**Department of Energy**  
Field Office, Albuquerque  
Los Alamos Area Office  
Los Alamos, New Mexico 87544

Ms. Barbara Hoditschek, Program Manager  
RCRA Permits Program  
Hazardous and Radioactive Materials Bureau  
New Mexico Environment Department  
525 Camino de los Marquez  
Santa Fe, NM 87502

Subject: Revised Closure Plan, NE & NW Surface Impoundments,  
TA-53, OU 1100

Figure K-1. Locations of Unit Risk Areas (500 m<sup>2</sup>)

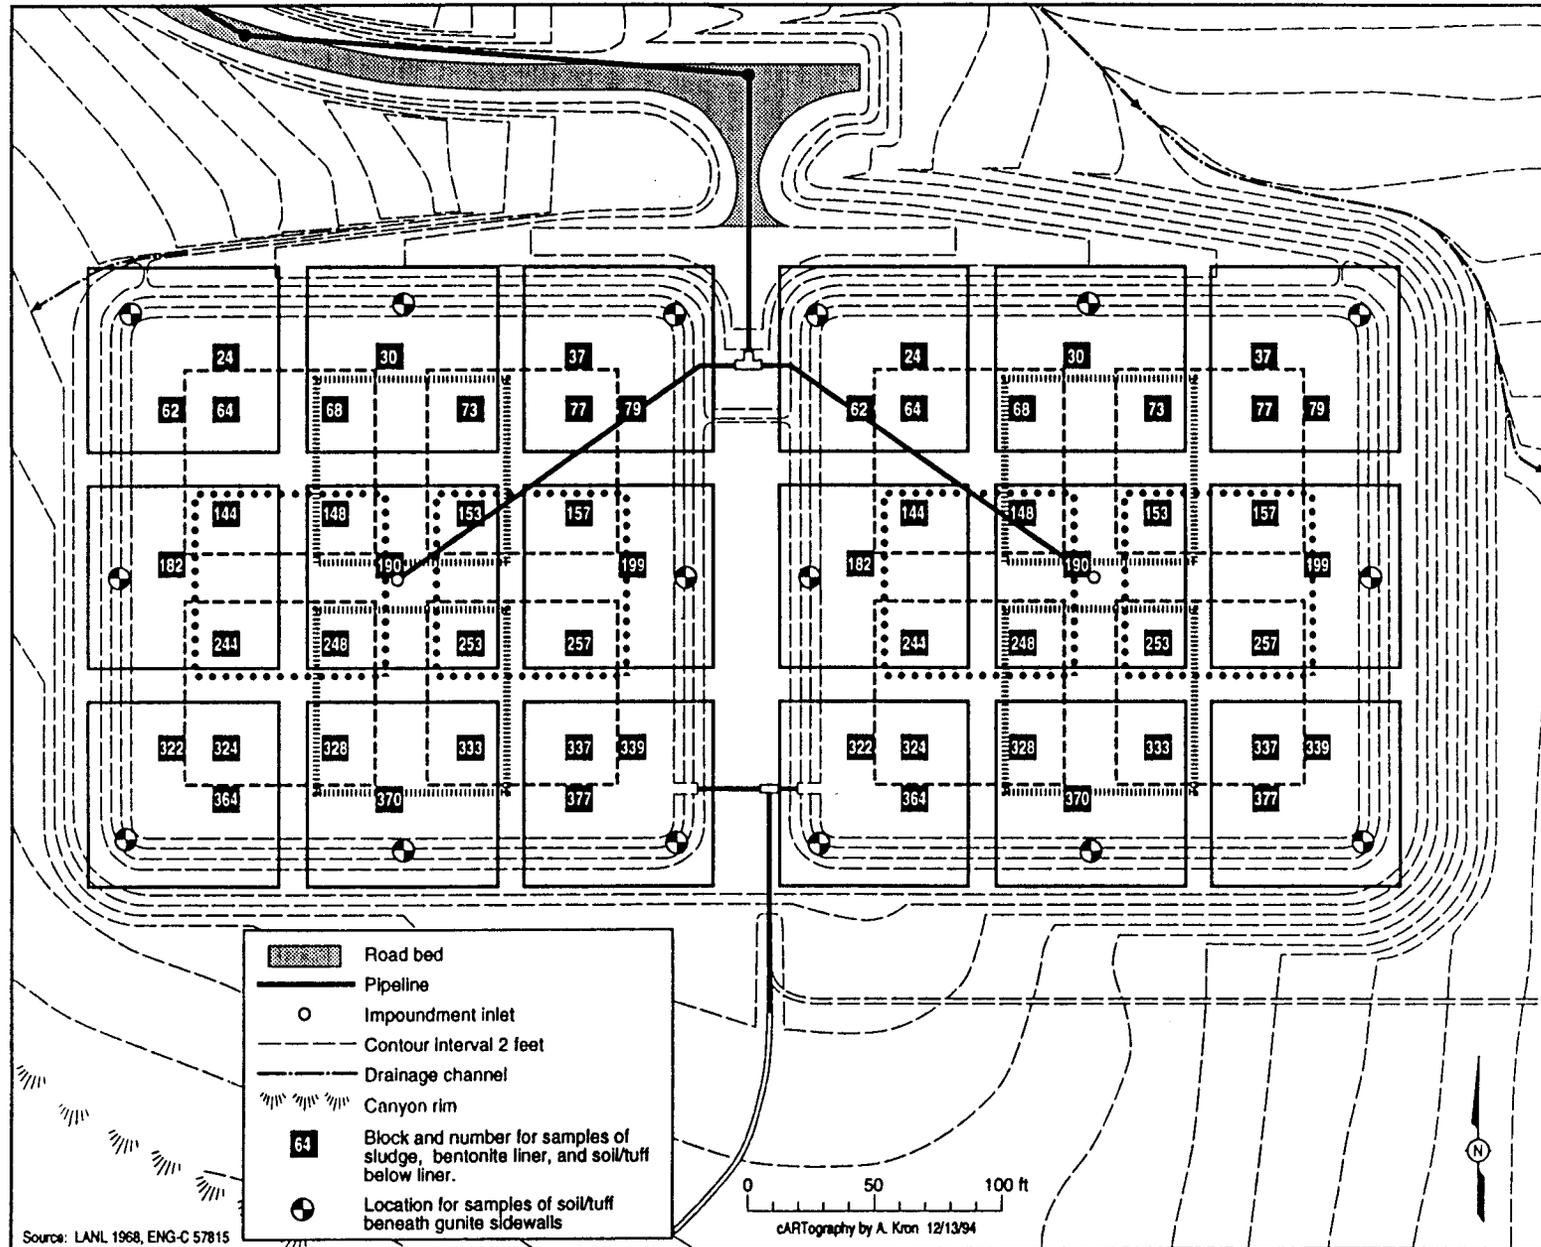
**Comment 29, Page K-2, Figure K-1, Summary of Data Evaluation Process.**

**Comment 33, Page K-6, Figure K-2, Locations of Exposure Units in Surface Impoundments.**

The various squares represented on the map represent the various exposure unit locations as discussed on page K-5, Section K.2, paragraph 2. There is no difference between squares with solid, dashed, or dotted lines. This was drawn in this manner to help identify individual exposure units. This rationale was presented to the NMED on 11/9/94 and accepted. However, the text in this section has been changed to reflect an error and a proposed change in sampling plans.

The number of proposed samples has been increased to assure a minimum of 3 samples per exposure unit (see revised Figure K-2, attached). If the sampling plan is approved by the NMED, then the body of the text in Section 3 and accompanying figures will be changed to reflect the additional sampling locations.
